ASSEMBLY INSTRUCTIONS FOR TENSIONER 55262

TECHNICAL INFO NO. 1076

Ford | Galaxy, Mondeo IV, S-Max

1.8 TDCi

Image 3: Bolts

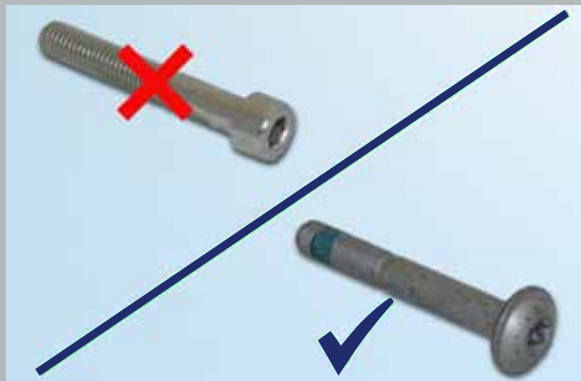
When installing the tensioner 55262 offered by RUVILLE, it is imperative to ensure that the bolt removed from the old tensioner is replaced with the new bolt enclosed (Image 3).

You must use the new bolt enclosed with the tensioner!
